ADDENDUM NO. 01

Project No.24076

Project Name: TFSD Lincoln HVAC Replacement
Address: Twin Falls, Idaho

Date Issued: March 27, 2025

Sheet No:
A9.11b

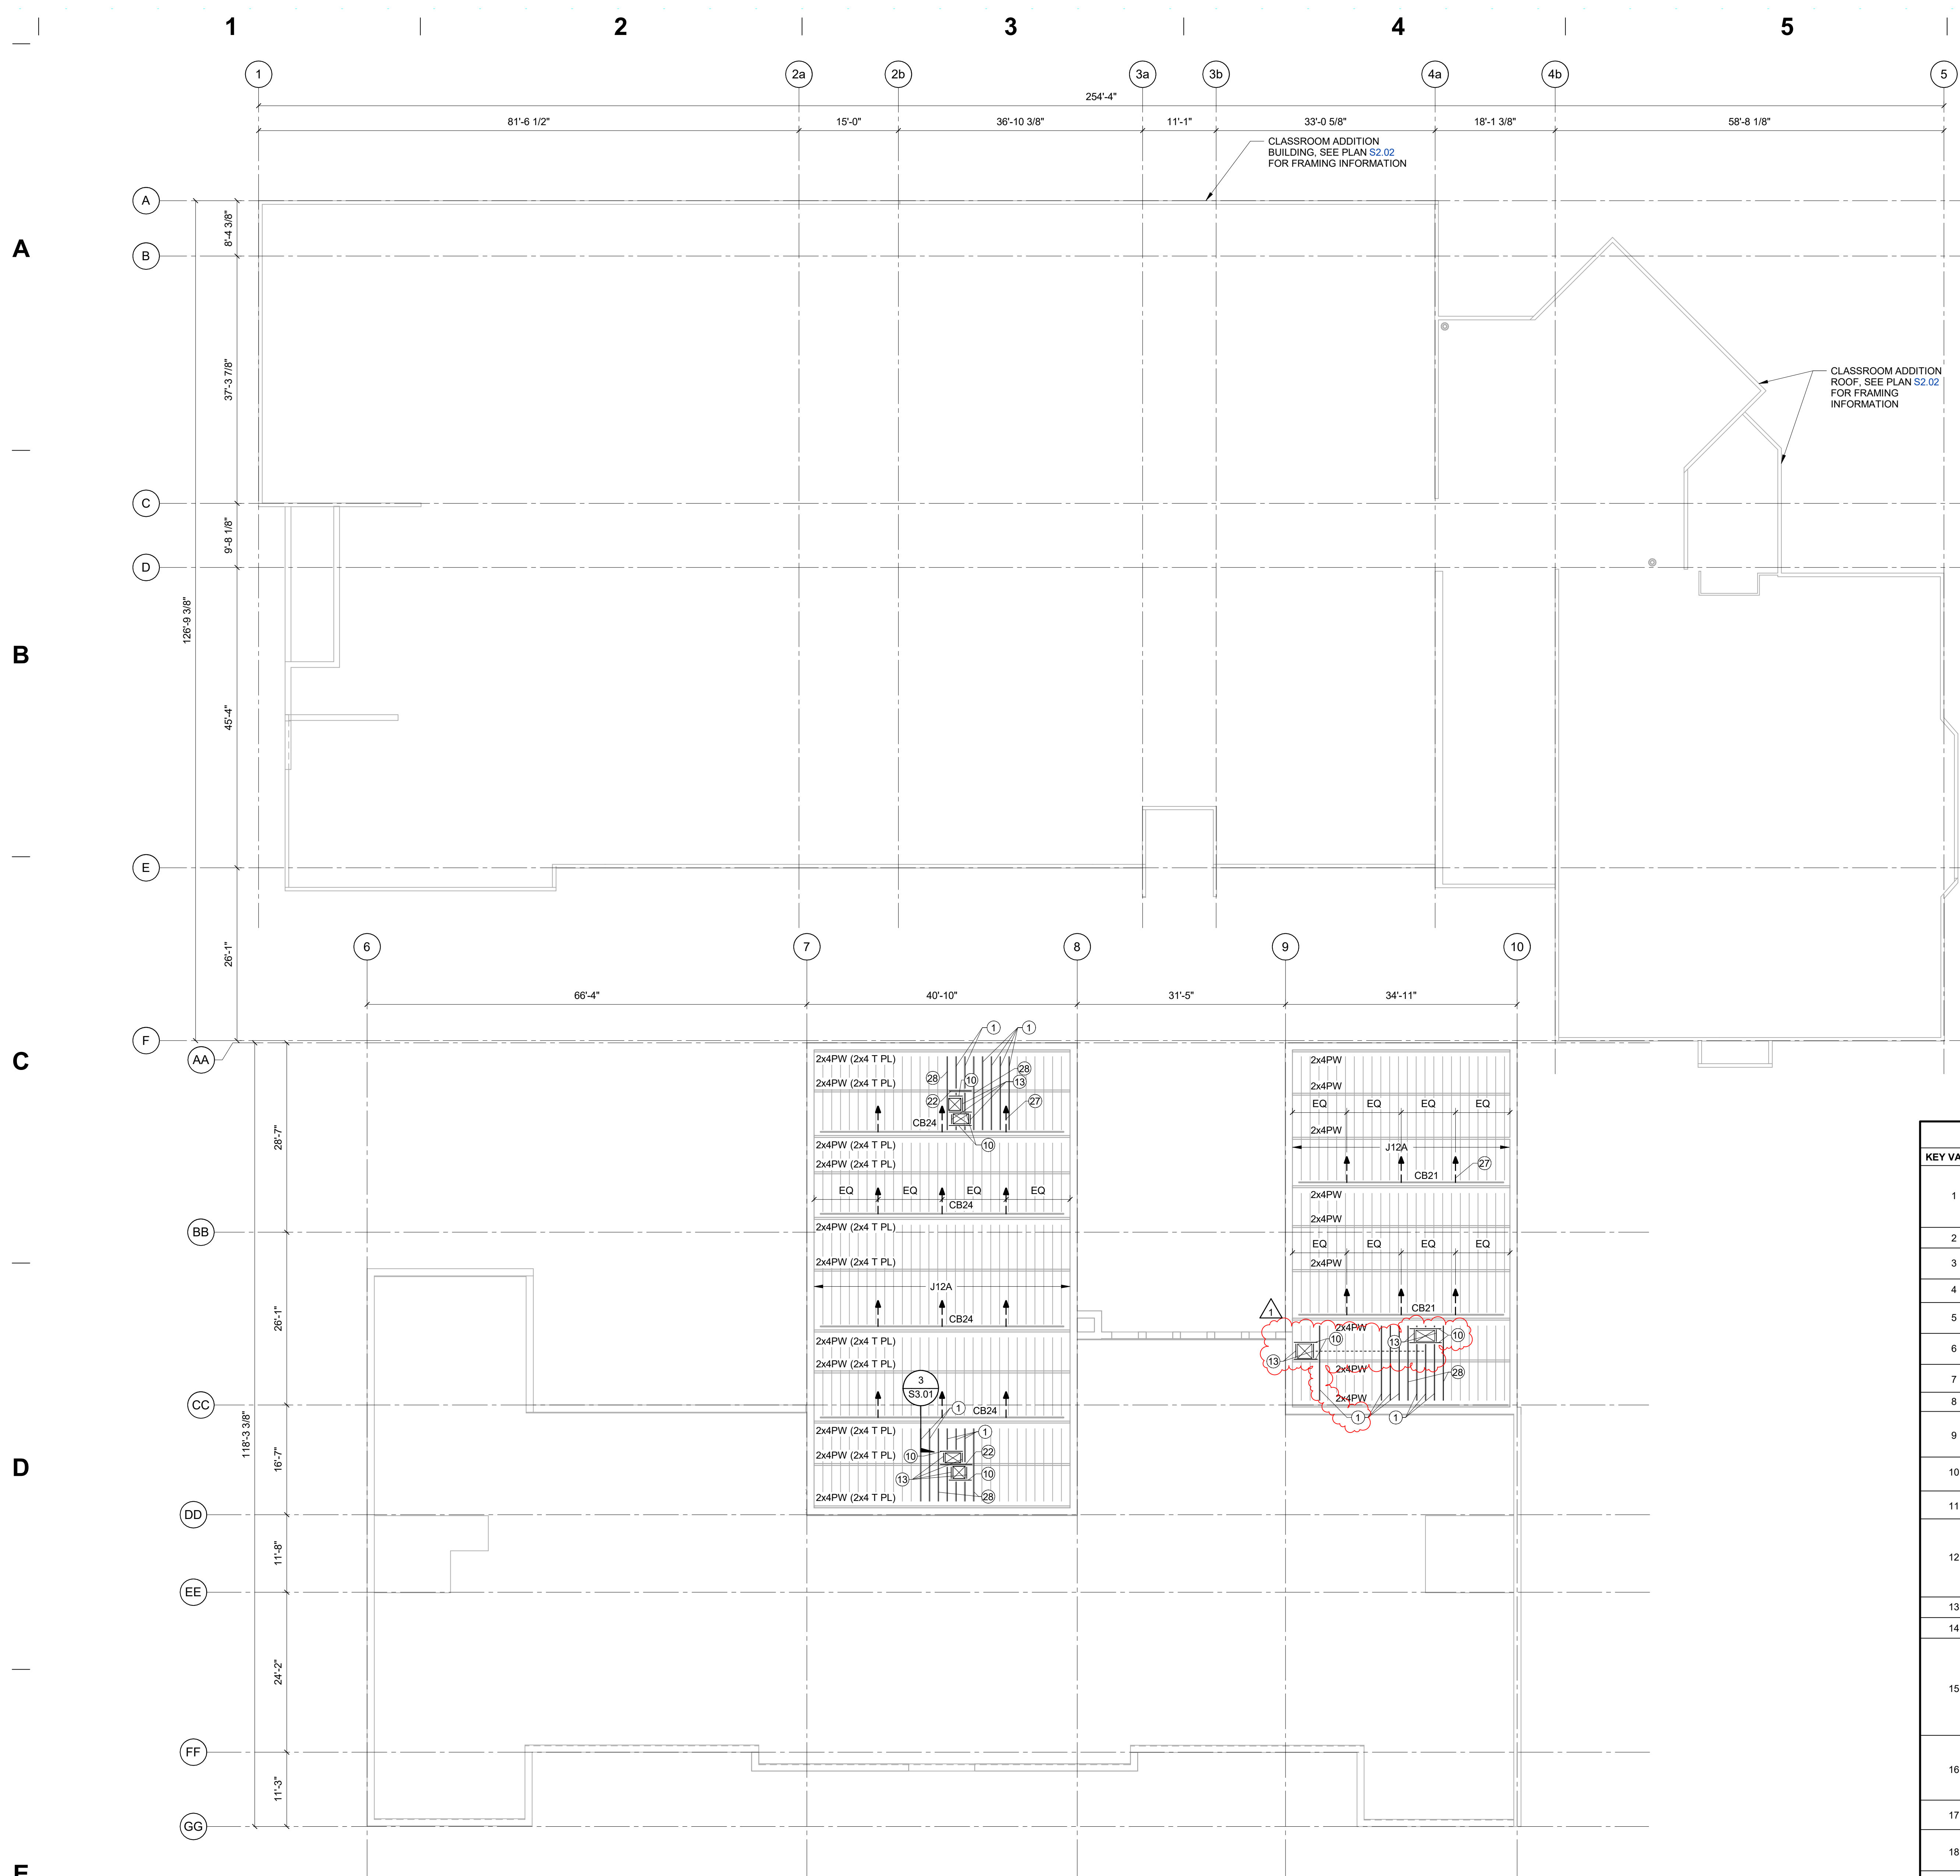
A9.11b: LEVEL 01 - CEILING PLAN AREA 'B'

1. NEW DUCT ROUTE IN PHYSICAL EDUCATION ROOM.

Sheet No: **E2.01**

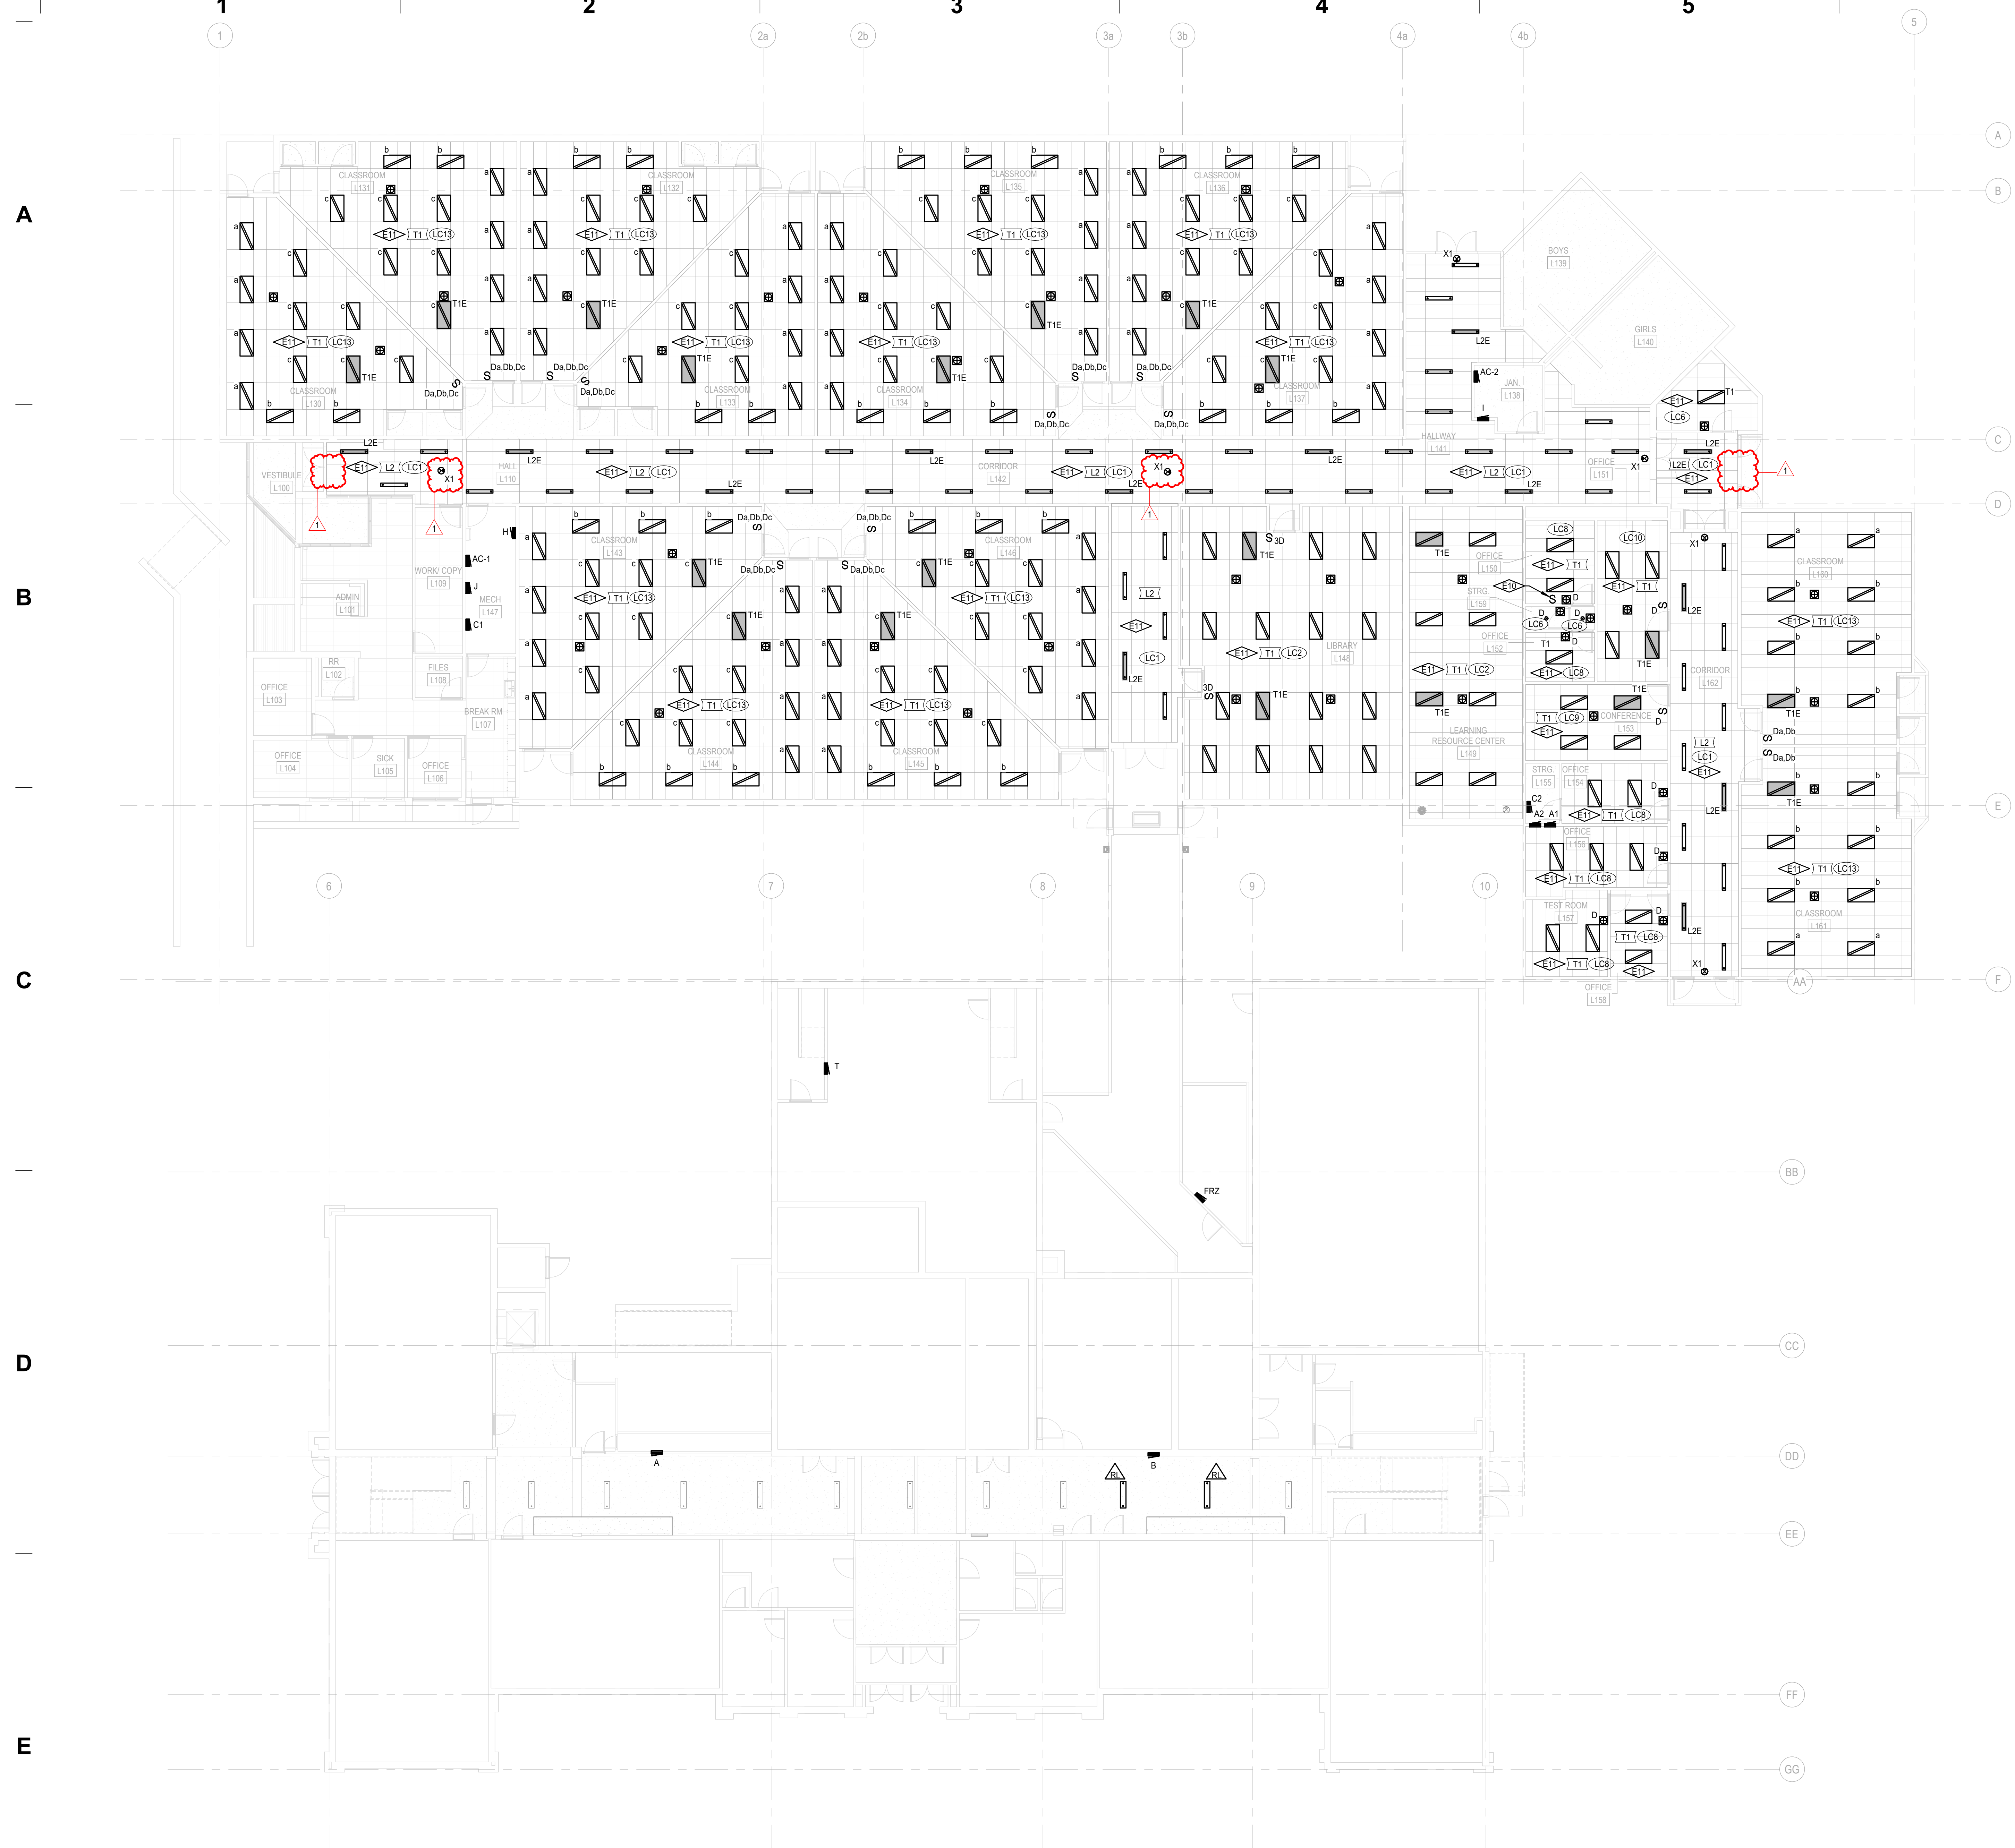
E2.01 – LEVEL 01 – COMPOSITE LIGHTING PLAN

1. REVISED PLANS TO SHOW EXIT SIGNAGE TO MATCH EXISTING

Sheet No:
 ED2.01

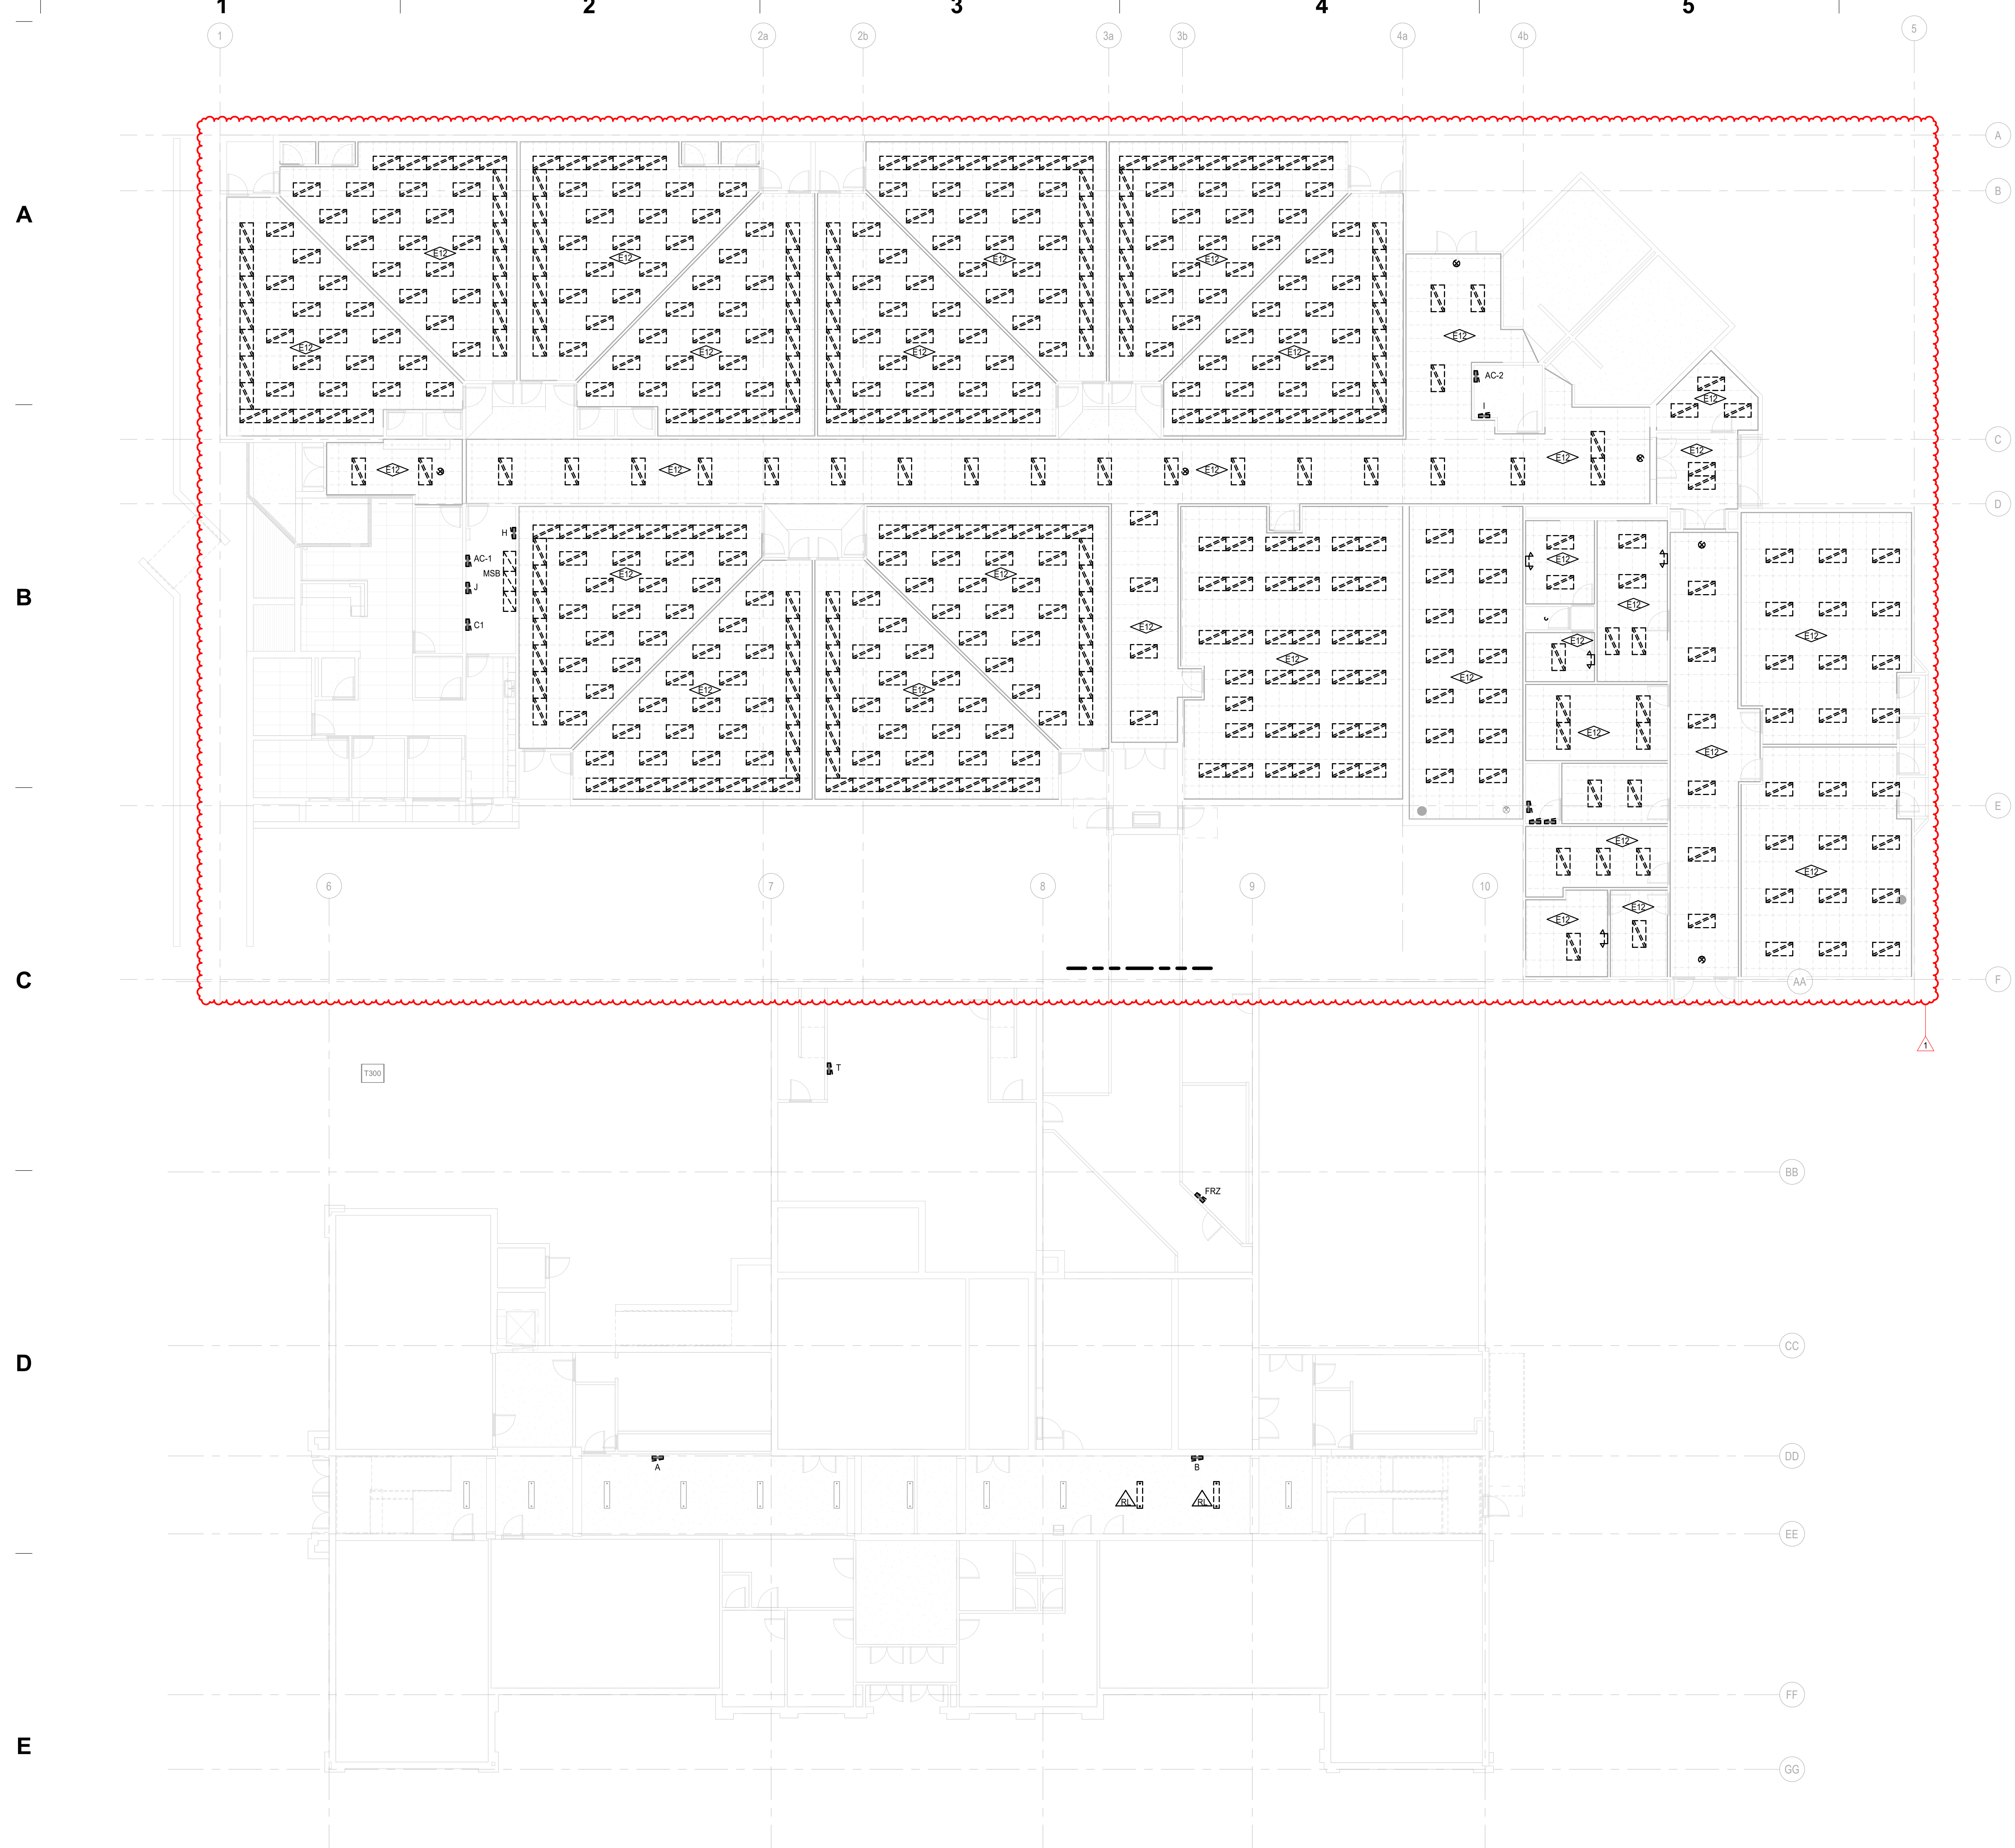
ED2.01 – LEVEL 01 – COMPOSITE LIGHTING DEMOLITION PLAN

1. REVISED PLANS TO SHOW EXISTING LIGHTING TO BE REMOVED
